# **SPARC Enterprise M3000/M4000/M5000/ M8000/M9000 Servers**

Product Notes for XCP Version 1119

Manual Code: C120-0013-01EN  
January 2015, Revision A

**FIGURE 1-13** M9000 Server (Base Cabinet) Installation Area

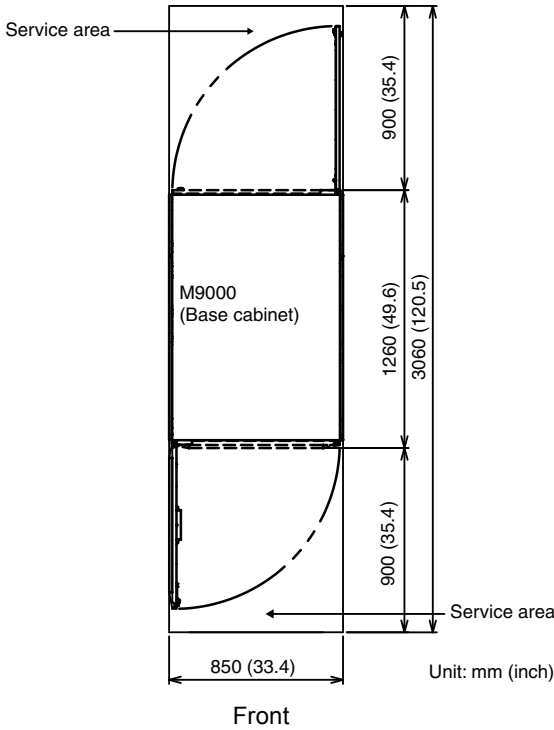
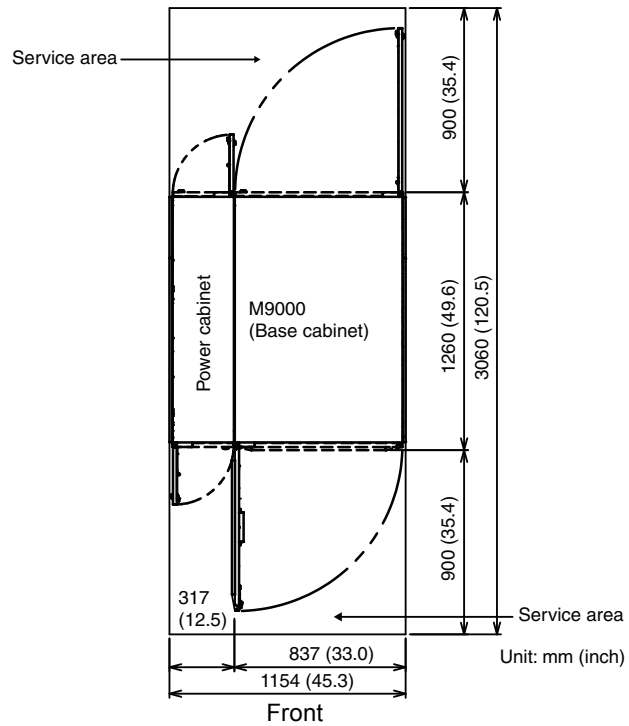
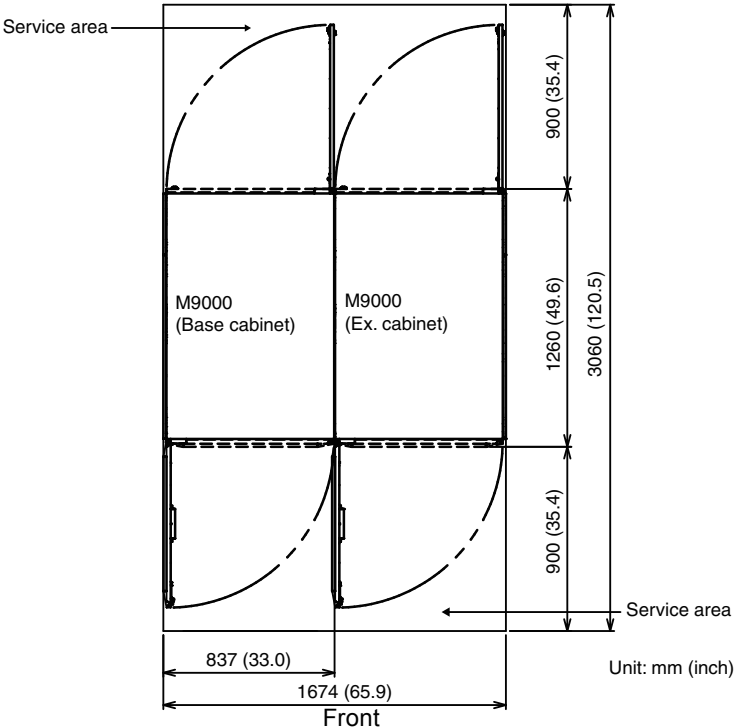
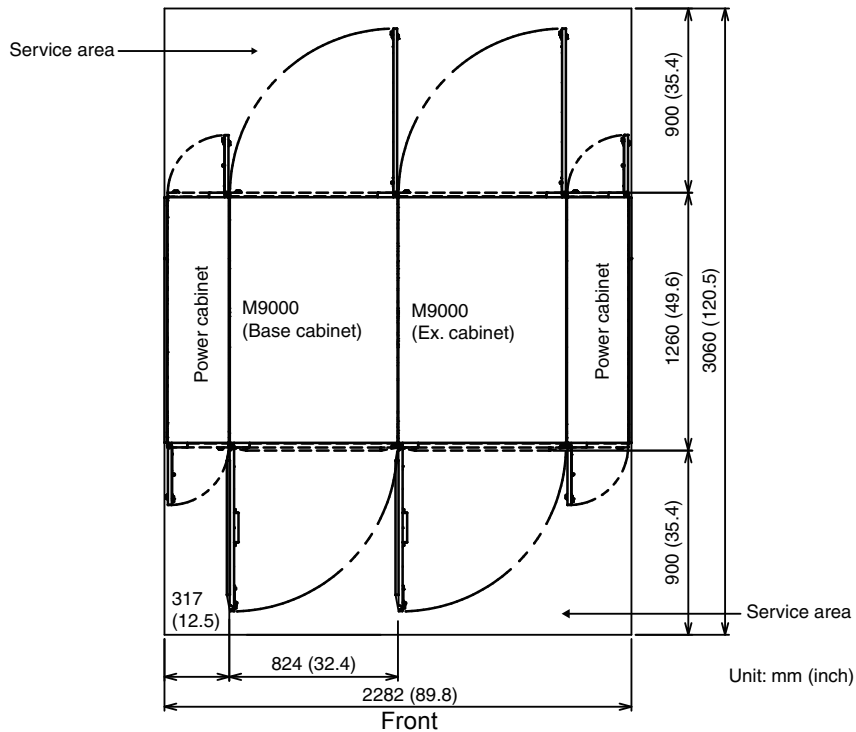
SPARC Enterprise M8000/M9000 Servers Site Planning Guide	1-18	A part of values in inches on FIGURE 1-13 to FIGURE 1-16 will be corrected. For detail, see <a href="#">“M9000 Servers Installation Area” on page 119</a> .
	1-35	For the order number of Vibration-proof bracket and Vibration-proof feet, see <a href="#">“Miscellaneous Information” on page 123</a> .
SPARC Enterprise M8000/M9000 Servers Service Manual	7-8	The mounting location of I/O Unit (IOU) indicated on FIGURE 7-4 will be corrected. For detail, see <a href="#">“I/O Unit (IOU) Mounting Locations” on page 122</a> ."

The following information supersedes the information in the *SPARC Enterprise M8000/M9000 Servers Site Planning Guide*
